FINAL SAFETY EVALUATION REPORT
TRANSNUCLEAR, INC.
STANDARDIZED NUHOMS® HORIZONTAL MODULAR STORAGE
SYSTEM FOR IRRADIATED NUCLEAR FUEL
DOCKET NO. 72-1004
CONVERSION OF TECHNICAL SPECIFICATIONS TO STANDARD
FORM AND ADDITION OF LIGHT WEIGHT TRANSFER CASK (OS197L)
AMENDMENT NO. 11

Figure 1.3 NUHOMS® OS197L TC System Decontamination Area Shielding

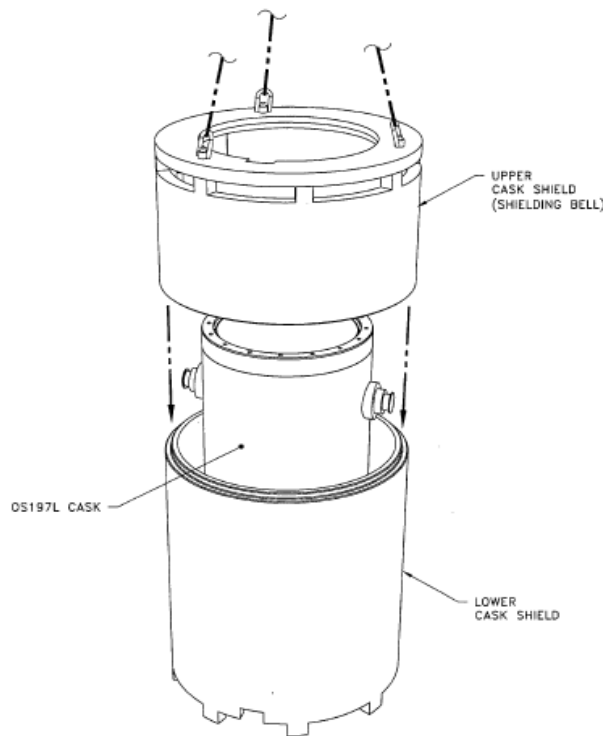
An evaluation was performed by the applicant to confirm that the radial gap between the OS197L TC and the inner diameter of the decontamination shield is sufficiently large, and that the top and bottom cut-out openings are of sufficient size as to not adversely affect the thermal performance of the OS197L TC. The decontamination area shielding is illustrated in SAR Figure W.1-2, and reproduced in Figure 1.3.

The applicant's evaluation is based on analysis of the free convection turbulent boundary layer development along the outer OS197L TC surface during vacuum drying and helium backfilling operations. The applicant states that the results of the evaluation confirm that the DSC shell-decontamination shield gap and the area of the inlet and outlet openings are adequate and, thus, the decontamination area shield does not adversely impact the cask boundary conditions assumed in the thermal analysis. No details of the analysis conducted by the applicant were provided in the SAR; however, in response to staff RAIs the applicant provided additional details for staff review.

Figure 5-3 Peak Component Temperatures for 32PT DSC in OS197L TC: Off-Normal Conditions of Transfer (117°F ambient)

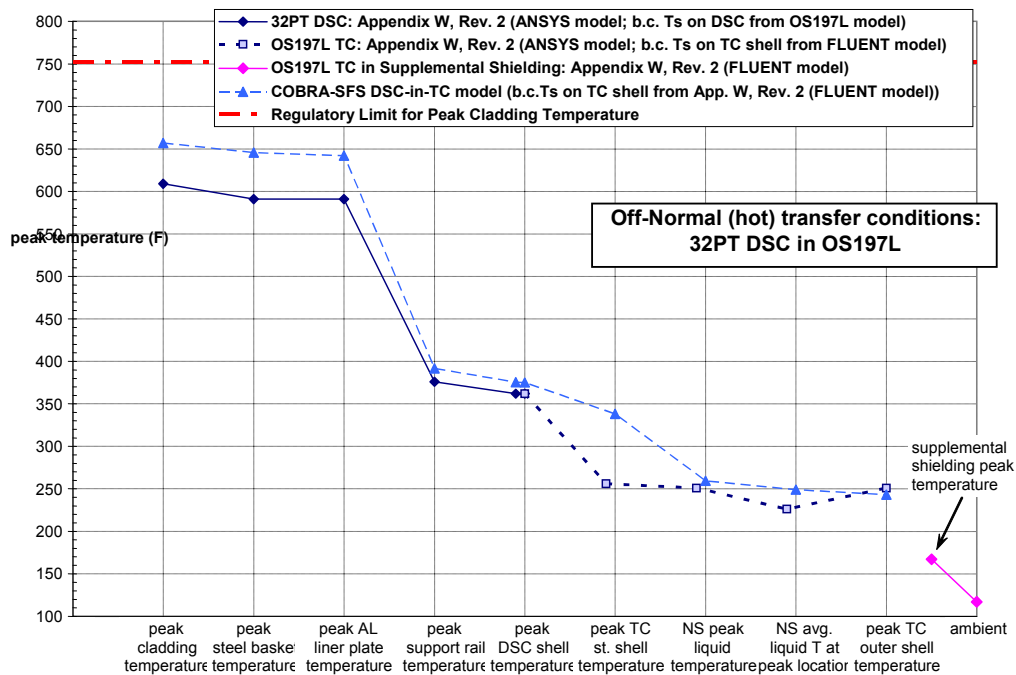
As indicated in Figure 5.3 above, the non-conservative results obtained with the SAR model compared to the confirmatory calculations can be further illustrated by comparison with results reported in Appendix M, for the 32PT within the original (heavier) OS197. Figure 5-6 shows the results for the 32PT using the DSC shell temperatures reported in Appendix M. As with the comparison for Appendix W (shown in Figure 5-5), the confirmatory calculation results are more conservative than those obtained with the ANSYS model documented in Appendix M. The peak cladding temperature predicted in the confirmatory calculations is approximately 24°F higher than the value obtained with the ANSYS model and reported in the SAR. However, for the 32PT DSC within the OS197, which does not require supplemental shielding, the peak cladding temperature obtained in the confirmatory calculations is 13°F below the temperature limit, and therefore the results obtained with the methodology documented in Appendix M were deemed acceptable.

For application to the analysis of the 32PT within the OS197L as presented in Appendix W, however, the non-conservatism of the methodology from Appendix M with respect to the confirmatory calculations is unacceptable, because the peak cladding temperatures are predicted to be much closer to the limit. The results obtained in the confirmatory calculations

predict peak cladding temperatures that are above the regulatory limit for normal and off-normal

Figure 5-4 Peak Component Temperatures for 32PT DSC in OS197L TC: Normal Conditions of Transfer (100°F ambient)

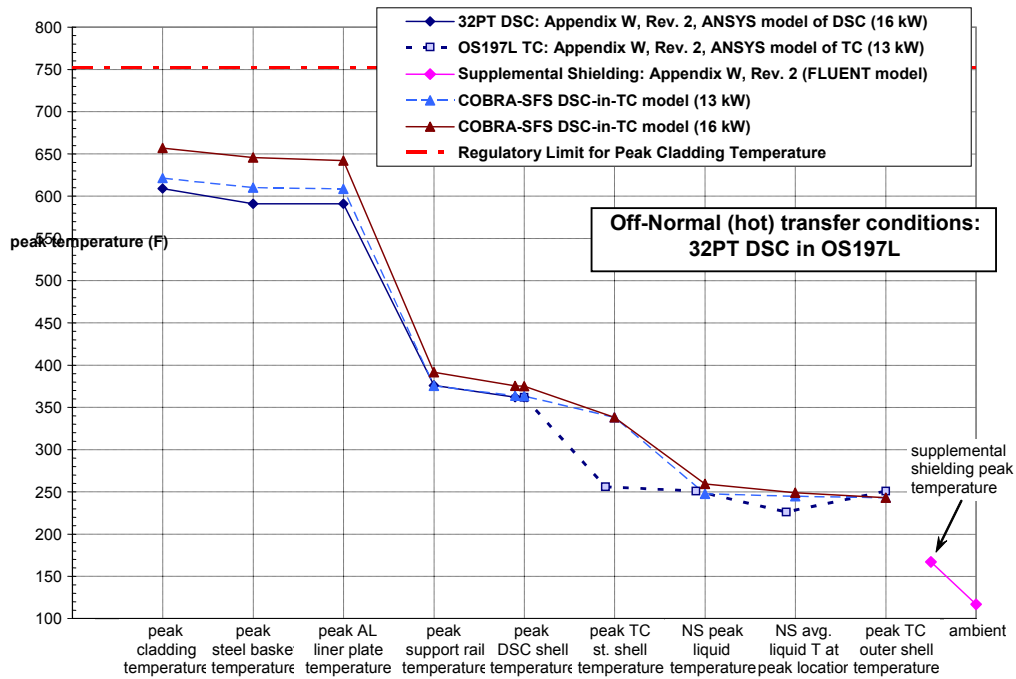
The temperature profile comparisons in Figures 5-3 and 5-4 show very good agreement in the results obtained for the OS197L transfer cask, and the peak DSC shell temperatures differ by

only about 16°F. The peak temperatures predicted for the aluminum support rails differ by approximately the same amount, with the confirmatory calculation results the more conservative of the two. (This is also in contrast to the results for the DSC model shown in Section 4.5.4, in which the SAR model results are more conservative than the confirmatory calculations.) Figure 5-5 shows this conclusively, with confirmatory calculation results with a COBRA-SFS model of the DSC only compared to Appendix W results for the detailed DSC model. In this comparison, both calculations use the same boundary temperatures on the DSC outer shell.

Figure 5-7 Peak Component Temperatures for 32PT DSC within OS197 TC, with and without supplemental shielding: Off-Normal Conditions (117°F ambient)

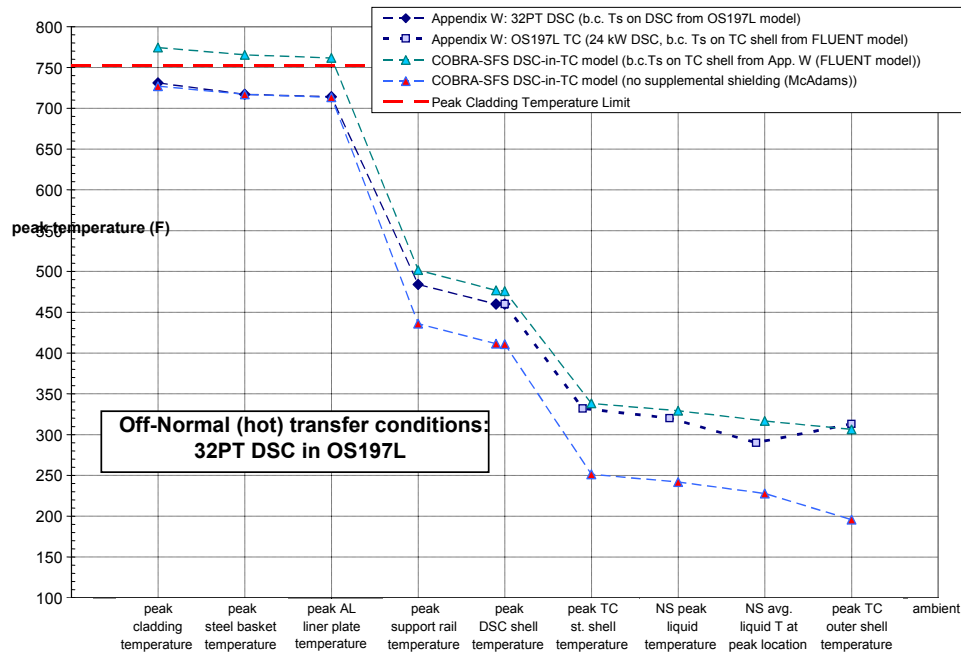
The results obtained for this case are compared to the SAR Appendix W results in Figure 5-7. The confirmatory calculations indicate that without the supplemental shielding, the peak temperature on the OS197L external surface would be more than 100°F lower than the value predicted in the SAR Appendix W with the FLUENT model. As a result, the peak cladding temperature in the confirmatory calculation is only about 727°F, which is 4°F below the value predicted with the SAR methodology *with* the supplemental shielding in place. This further illustrates the non-conservatism of the detailed DSC model in the SAR.
